APPLICATION FOR A RESIDENTIAL SITE IMPROVEMENT PERMIT/ CONSTRUCTION AUTHORIZATION FOR AN ON-SITE WASTEWATER SYSTEM, NEW WELL INSTALLATION, OR REPAIR OF EXISTING WELL

Re: Application for improvement permit for: 5 Bedroom House
Property Location: 6529 Pargo Rd, Charlottee, NC 28216 (PID 033-073-11 & 12)
Health Department File Number: **11674B (App ID 13875)**

SOIL/SITE EVALUATION for ON-SITE WASTEWATER SYSTEM

PROPOSED PLOT PLAN

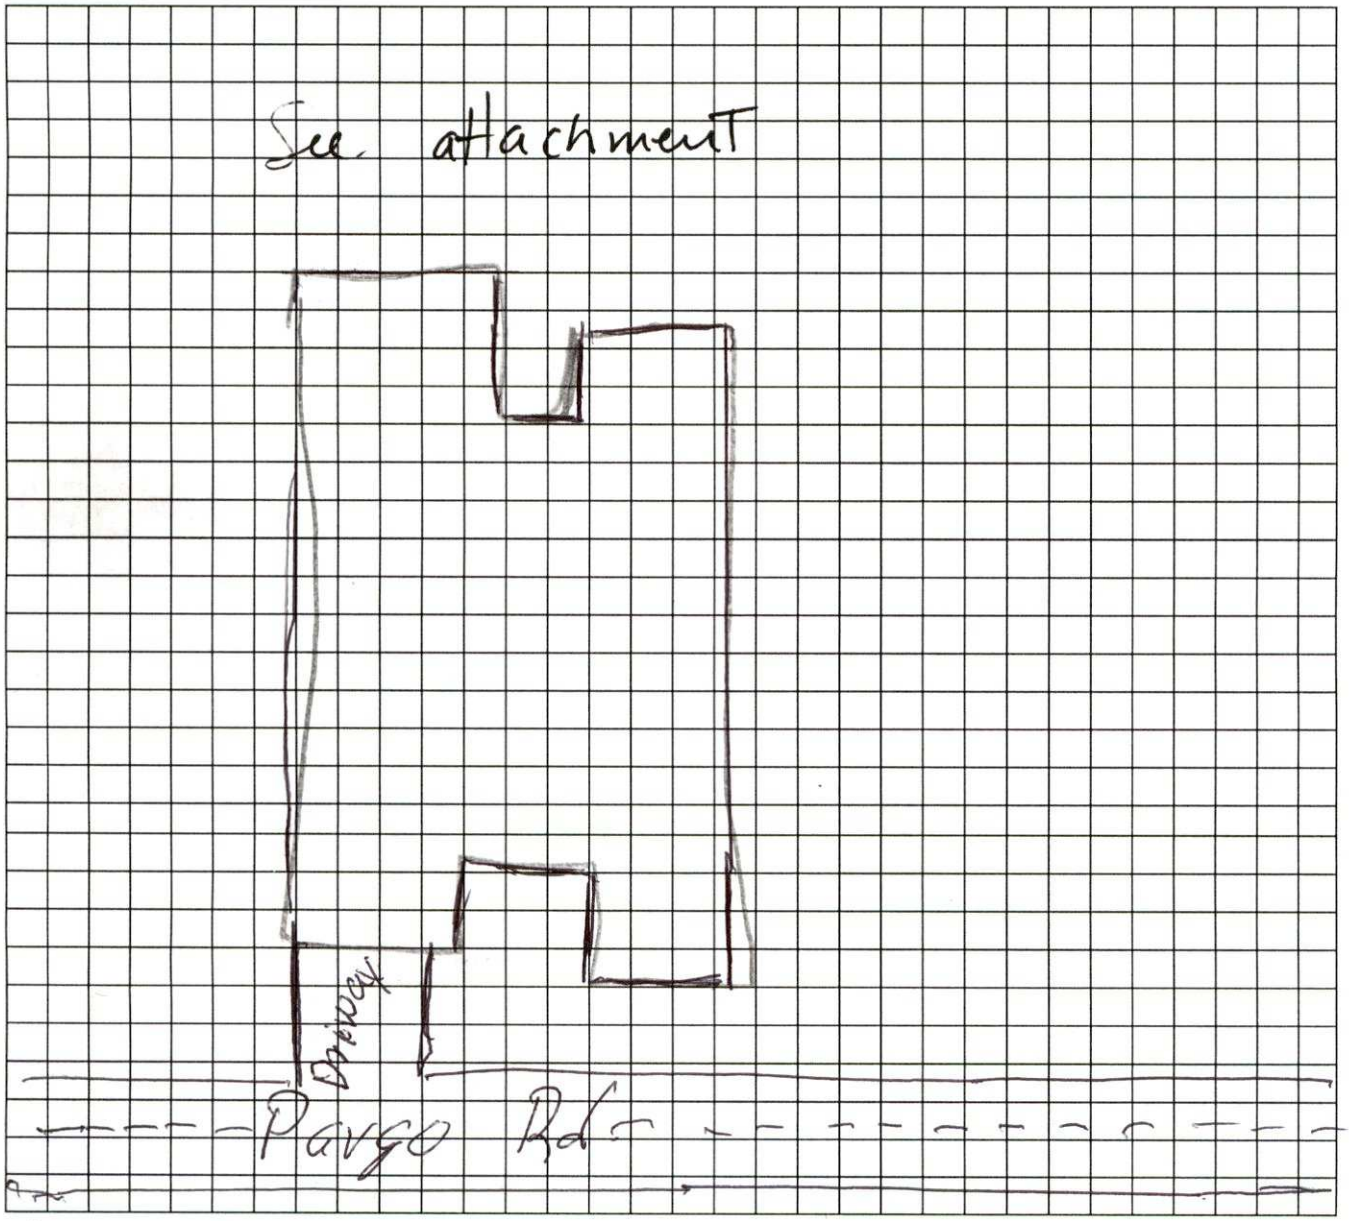
Based on the criteria set out in Title 15A, Subchapter 18A, of the North Carolina Administrative Code, Rules .1940 through .1948, the evaluation indicated that the site is **UNSUITABLE** for a ground absorption sewage system. Therefore, your request for an improvement permit is **DENIED.** A copy of the site evaluation is enclosed. The site is unsuitable based on the following:

- ☒ Unsuitable soil topography and/or landscape position (Rule .1940)
- ☒ Unsuitable soil characteristics (structure or clay mineralogy) (Rule .1941)
- ☒ Unsuitable soil wetness condition (Rule .1942)
- ☒ Unsuitable soil depth (Rule .1943)
- ☐ Presence of restrictive horizon (Rule .1944)
- ☒ Insufficient space for septic system and repair area (Rule .1945)
- ☐ Unsuitable for meeting required setbacks (Rule .1950)
- ☐ Other (Rule .1946)

However, the site classified as **UNSUITABLE** may be classified as **PROVISIONALLY SUITABLE** if written documentation is provided that meets the requirements of Rule .1948(d). A copy of this rule is enclosed. You may hire a consultant to assist you if you wish to try to develop a plan under which your site could be reclassified as **PROVISIONALLY SUITABLE.**

Sketch of Soil Evaluation Locations

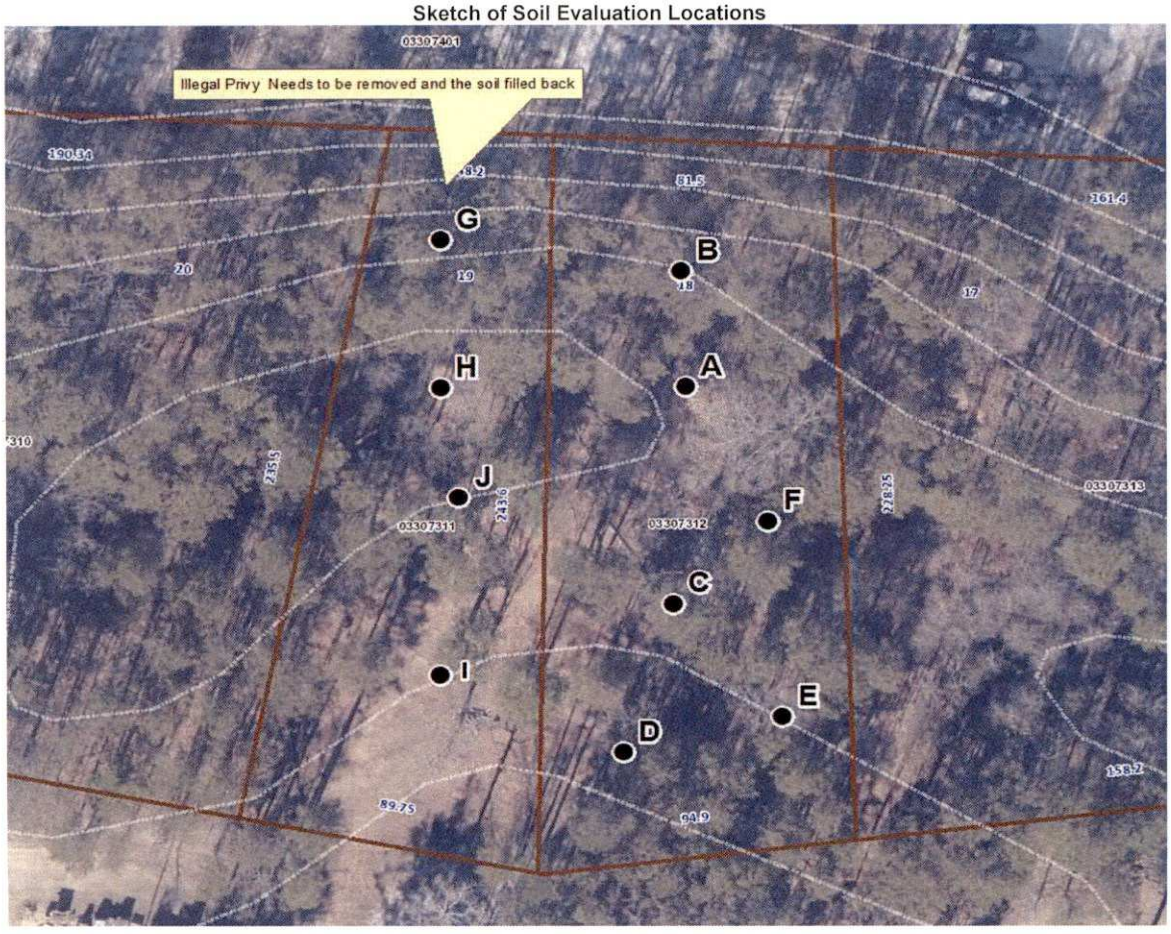
PROFILE #	.1940 Landscape Position/ Slope%	Horizon Depth (IN.)	SOIL MORPHOLOGY .1941 .1941 Structure/ Texture	.1941 Consistence Mineralogy	b PROFILE FACTORS .1942 Soil Wetness/ Color	.1943 Soil Depth (IN.)	.1956 Sapro Class	.1944 Restr Horiz	General Comments	Profile Class & LTAR	Maximum Trench Bottom Depth for 3' Wide Trench Low Side
Boring A	R 3%	0 - 9	gre/sbk SCL	SS SP FR SEXP							
		9 - 15	sbk/abk SC	S P FI SEXP	10YR 6/2	15	NA	NA	Auger Refusal at 20"	US	NA
		15 - 20	mass SCL	SS SP FI/VFI SEXP	at 10"						
Boring B	LS 5%	0 - 7	sbk SCL	SS SP FR SEXP							
		7 - 14	sbk/abk C	S P VFI EXP	10YR 6/2	14	NA	NA	Auger Refusal at 22"	US	NA
		14 - 22	mass SCL	SS SP FI/VFI SEXP	at 7"						
Boring C	R 2%	0 - 7	sbk SCL	SS SP FR SEXP							
		7 - 28	mass/sbk C	VS VP VFI EXP	10YR 6/2	7	NA	NA	Auger Refusal at 32"	US	NA
		28 - 32	Weathered Rock w/ SCL inclusions		at 7"						
Boring D	R 3%	0 - 5	gr SCL	SS SP FR SEXP

5 - 15	sbk SCL	SS SP FR SEXP	10YR 7/2	15	NA	NA		US	NA
		15 - 38	mass/sbk C	S VP VFI EXP	at 12"						
Boring E	R 3%	0 - 7	gr SCL	SS SP FR SEXP							
		7 - 12	mass C	VS VP VFI EXP	10YR 7/2	7	NA	NA	Auger Refusal at 18"	US	NA
		12 - 18	Weathered Rock w/ SCL inclusions		at 8"						
Boring F	R 2%	0 - 14	sbk SCL	SS SP FR SEXP							
		14 - 32	mass/sbk C	S VP VFI EXP	10YR 7/2	7	NA	NA	Auger Refusal at 40"	US	NA
		32 - 40	Weathered Rock w/ SCL inclusions		at 17"						
Boring G	LS 4%	0 - 4	gr SL	SS SP FR SEXP	10YR 6/2				grinding through LS		
		4 - 30	mass LS/SCL	SS SP FI SEXP	at 22"	4	NA	NA	24 - 30"	US	NA

Description	Initial System	Repair System
Available Space (.1945)	US	US
System Type(s)	NA	NA
Site LTAR (gpd/sq ft)	**US**	**US**

Other Factors (.1946):
Soil Evaluation By: Jacob Presley, LSS, REHS
Others Present:
Site Classification (.1948): Unsuitable
Site Evaluation By: Jacob Presley, LSS, REHS
Others Present:
